**Re: Development Permit Denial
2302 22nd St W (Mount Royal)
Restaurant (Wendy's)
B4 – Arterial and Suburban Commercial District**

The Planning and Development Division has reviewed your development permit application for a restaurant at 2302 22nd St W. The property is zoned B4 – Arterial and Suburban Commercial District and based on the information provided, the following deficiencies have been identified:

Wendy's
 22ND STREET WEST & AVENUE W
 SASKATOON, SASKATCHEWAN

PROPOSED FLOOR PLAN
 PROPOSED SITE PLAN

P1.0r1

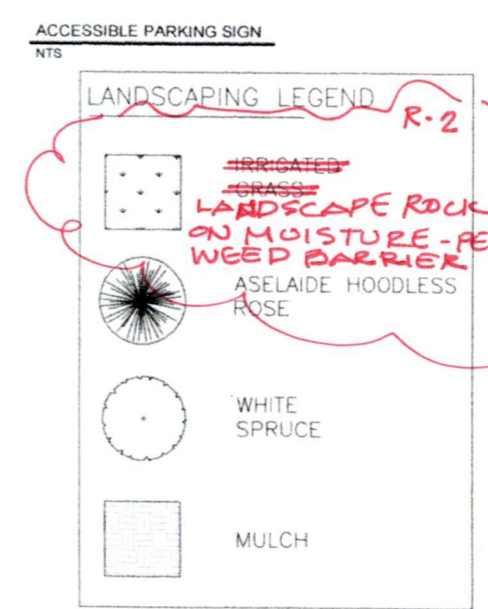
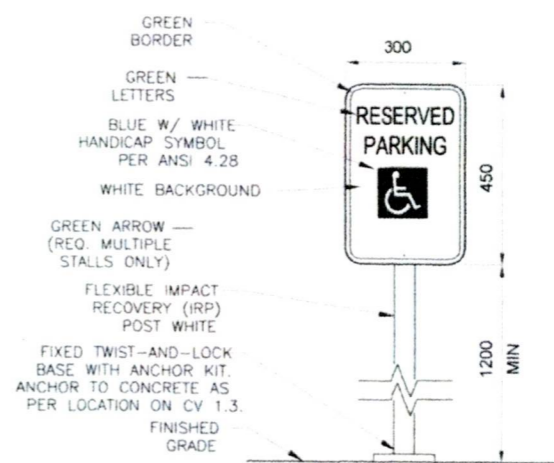
Proposed: The proposal includes landscape rock throughout the required 1.5m landscape strip along Avenue W and 3.0m required landscape strip along 22nd St W.

Deficiency: As per the definition of landscaping, rock or gravel cannot be used for hard landscaping and is not permitted in required landscaping strips.

Proposed: There is a proposed concrete space for the future bus rapid transit shelter shown within the 3.0m landscape strip along 22nd St W and is considered hard landscaping per the Zoning Bylaw definition of landscaping.

Deficiency: The area of the pedestrian walkway along with the area of the concrete for the future bus rapid transit shelter is covering approximately 34.27% of the required landscape strip along 22nd St W. This exceeds the maximum hard landscaping allowed by 9.27%.

Should the appeal not be granted, it would be required that a revised landscape plan be submitted that meets the Zoning Bylaw.
